**Subject:** Request for a Temporary Authorization for the Referenced Class 2 Permit Modification to the Waste Isolation Pilot Plant Hazardous Waste Facility Permit, Permit Number: NM4890139088-TSDF to Facilitate Changes to Protect Human Health and the Environment.

**Class 2 Permit Modification Request**

**Update Ventilation Language**

**Waste Isolation Pilot Plant  
Carlsbad, New Mexico**

**Figure 5**  
**Location of Worker Emplacing RH-TRU Mixed Waste**

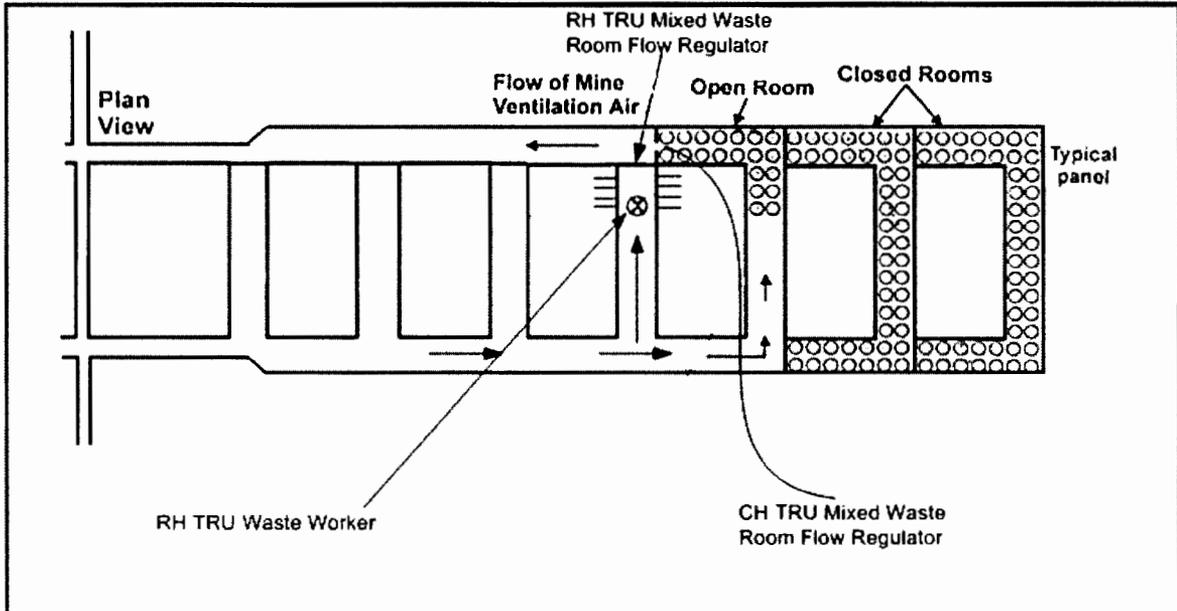
At the time the Permit was issued in 1999, RH TRU waste was prohibited and RH TRU waste emplacements were not included in the NMED's ventilation analysis. Rooms that are being filled with RH TRU waste represent one additional scenario as shown in Figure 5. As can be seen in Figure 5, the worker is unaffected by normal operations or a roof fall in the adjacent CH TRU mixed waste room and by any roof fall scenario in the adjacent filled room by virtue of the fact that the ventilation flow through the active CH TRU mixed waste room bypasses the active RH TRU mixed waste room. In other words, because RH TRU mixed waste rooms are upstream from CH TRU mixed waste rooms, the RH TRU mixed waste worker in an RH TRU

mixed waste room is never in the CH TRU mixed waste room ventilation stream, and therefore would not be subject to the consequences of the roof-fall scenario.

**Figure 6  
Current and Proposed Routes**

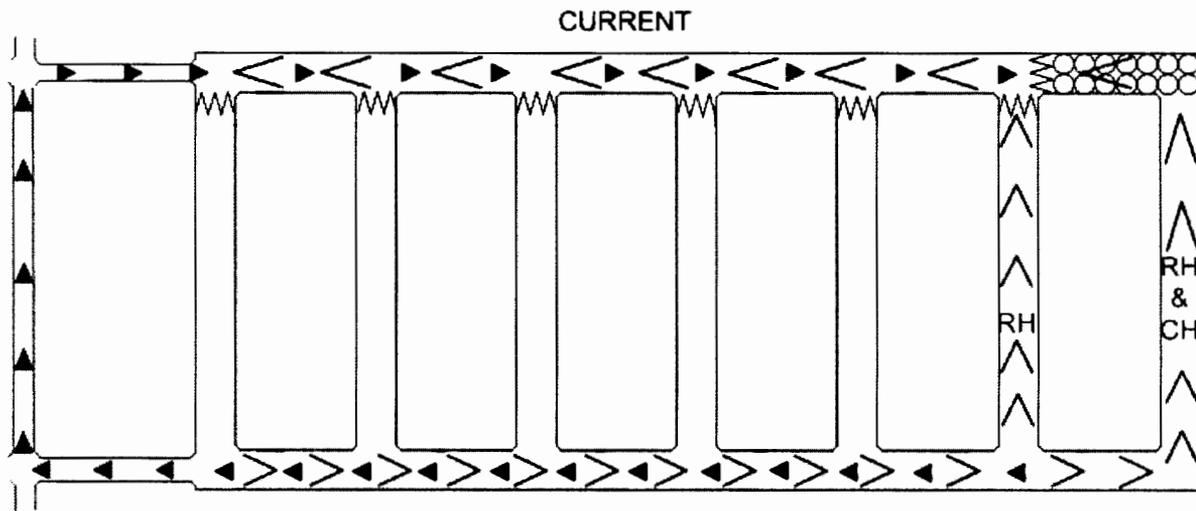
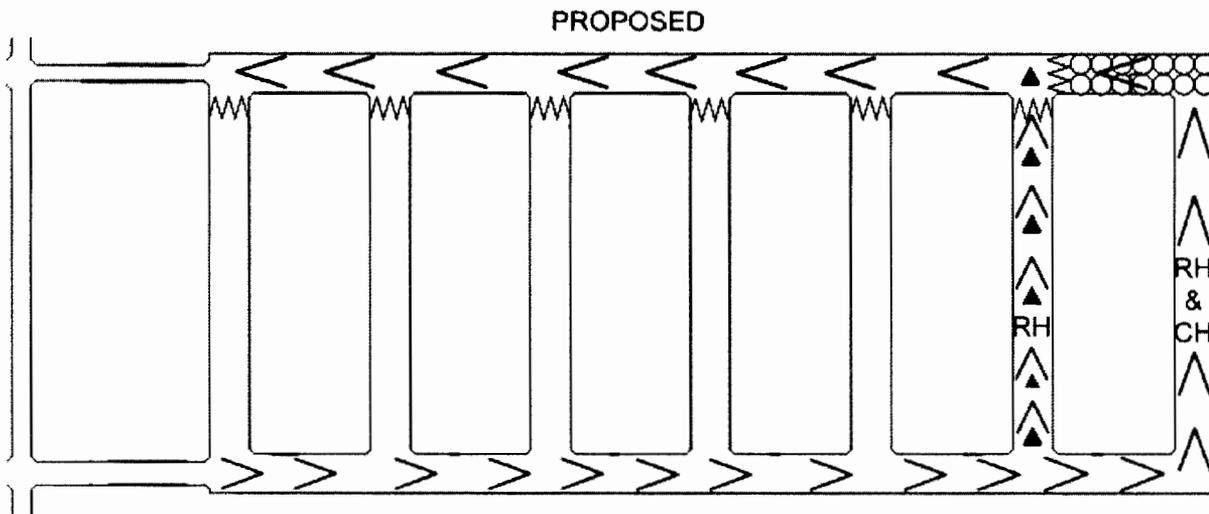
Figure 6 shows the current and proposed worker pathways to adjust the ventilation regulators. Clearly, the pathway allowed by this proposed modification is significantly shorter and thereby reduces the time that a worker must be downstream of the emplaced waste.
